**Project Description:** Commercial Plaza – Phase 1 (1 Building Pad as per the LLWS + 5 Buildings Base building)

**Project Address: 1300 Fanshawe Park Rd E, London, ON N5X 3Z8.**

Based on RFIs received, and clarifications from consultants, please see below and Attached:

**RFI # 16 :**

Drawing No: **A-3.2** Revision: **6**

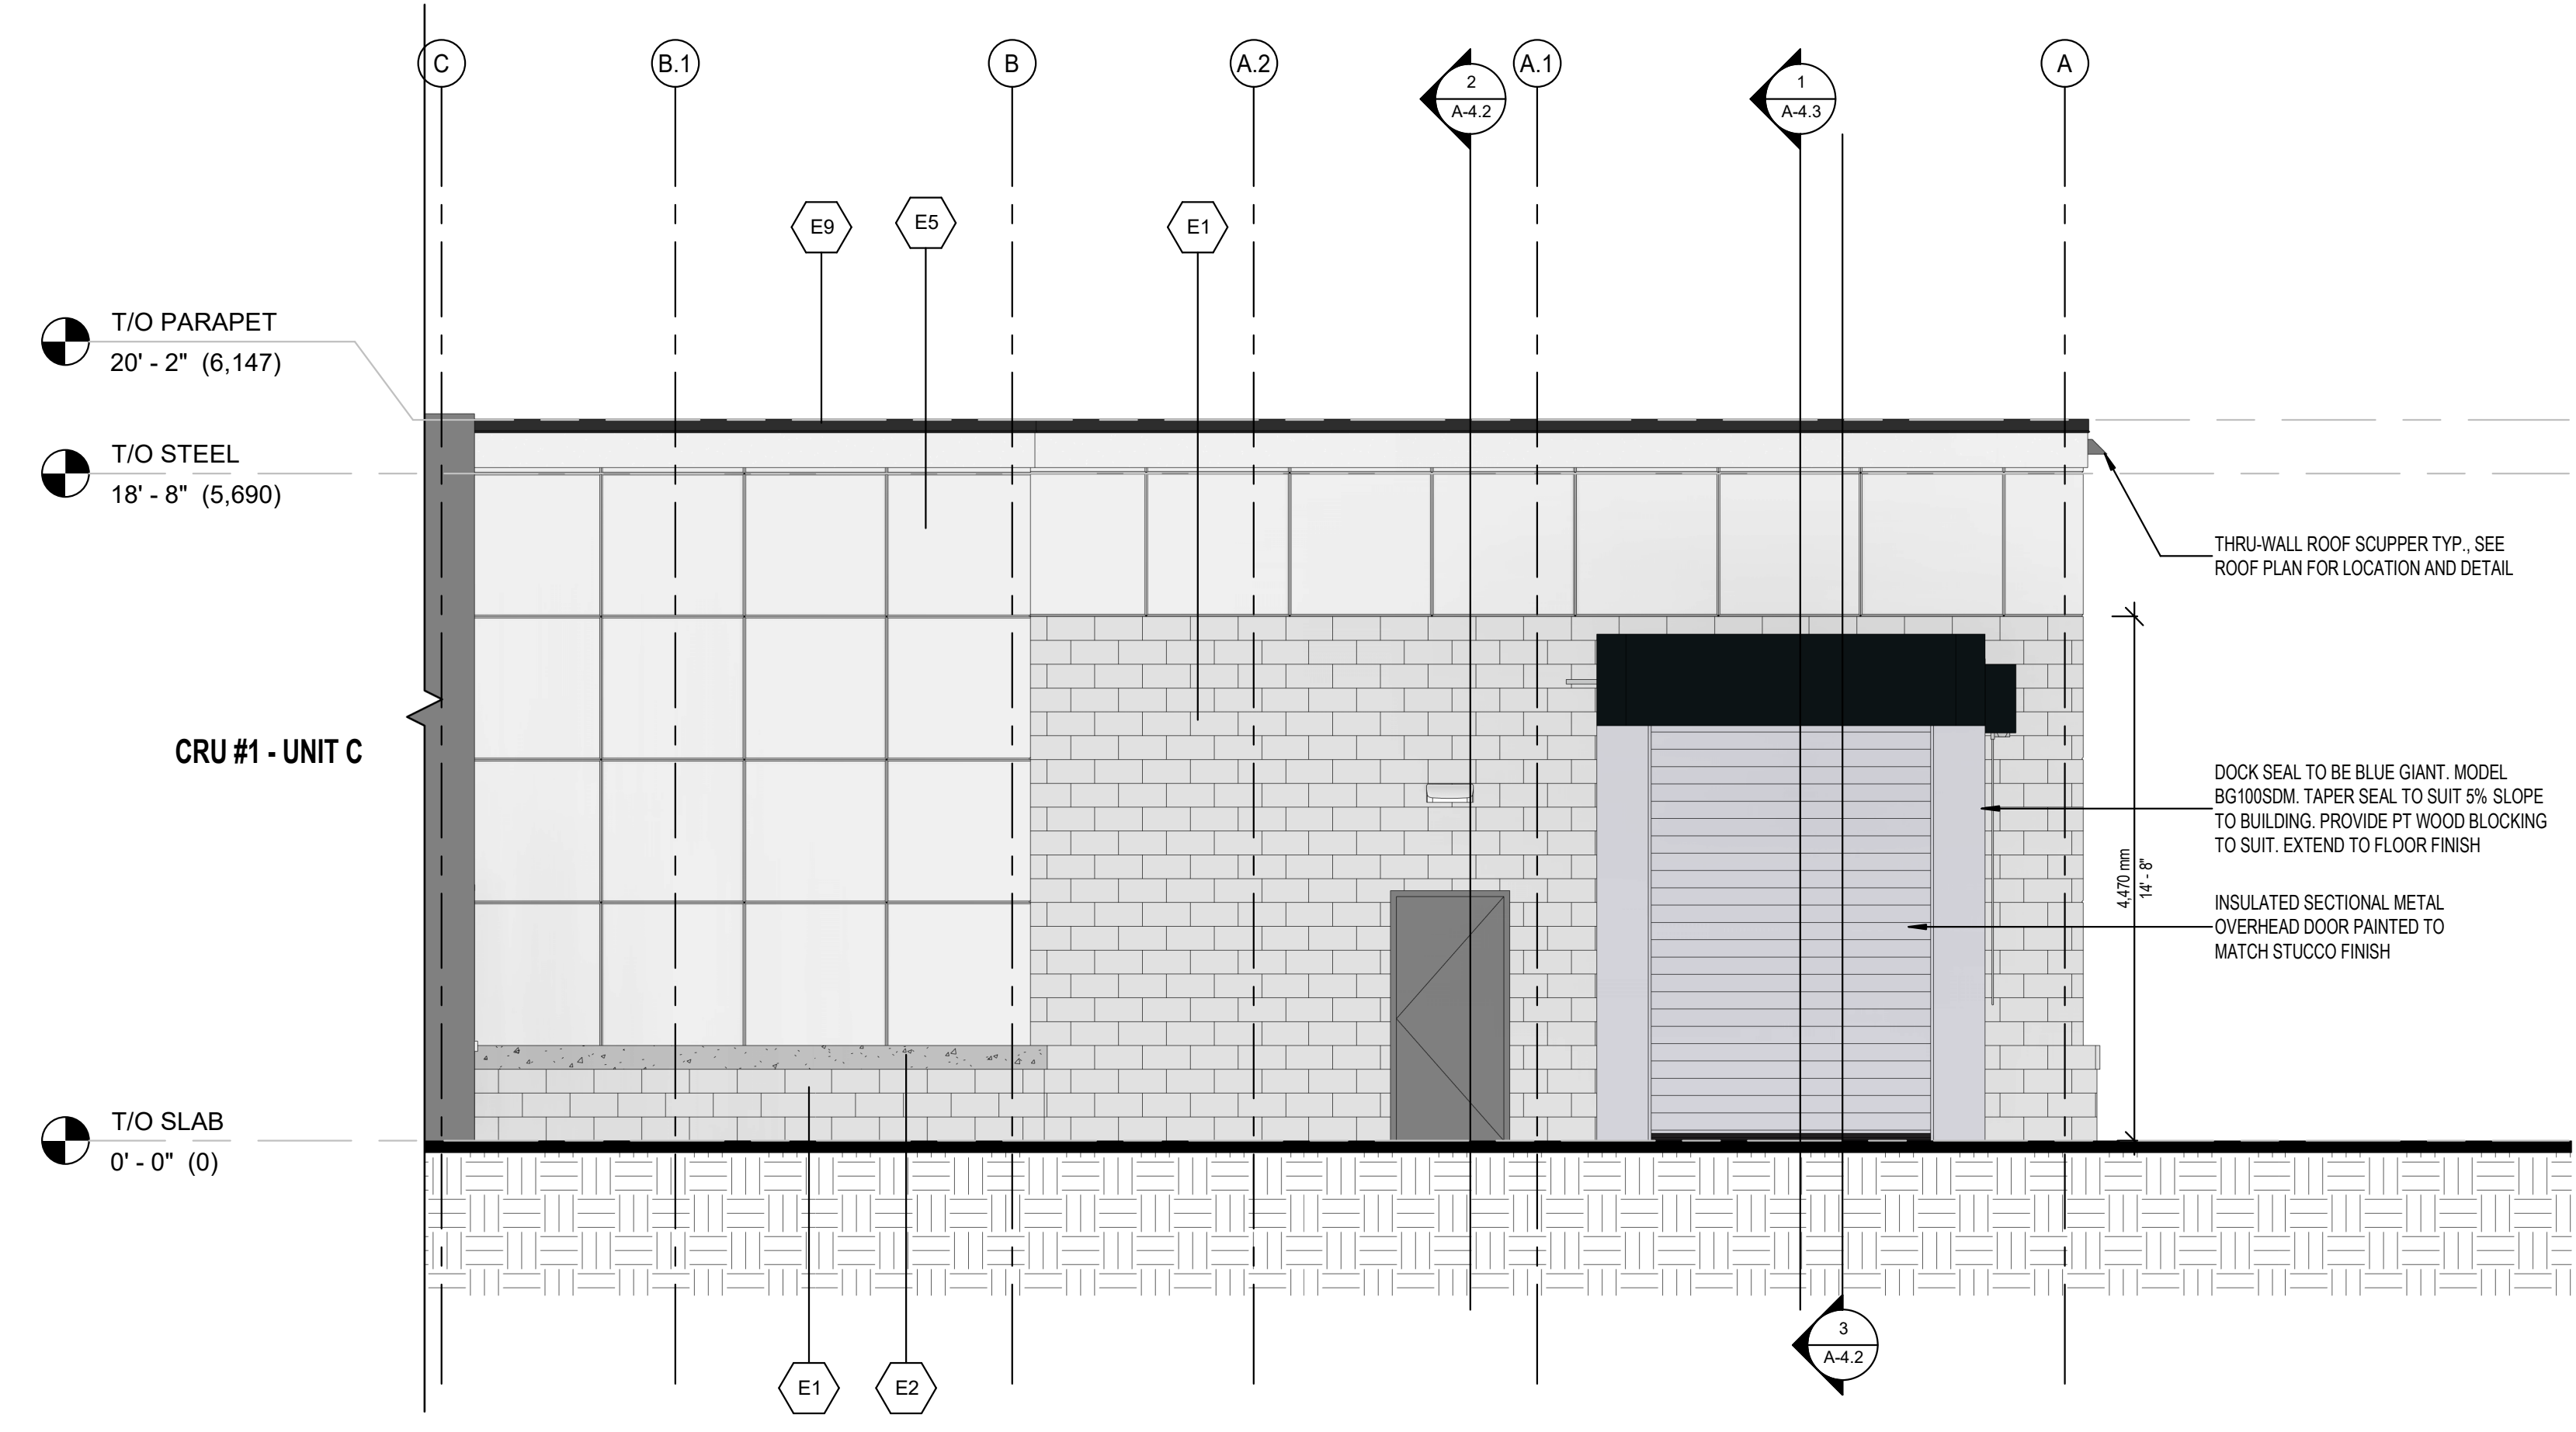
**a) legend texts are overlapping all through the legend chart. However, the image attached shows the finish type for precast concrete sill is unclear due to overlapping text. Please clarify.**

- Response: Refer to revised sheet A-3.1 & 3.2. Material Legend has updated.
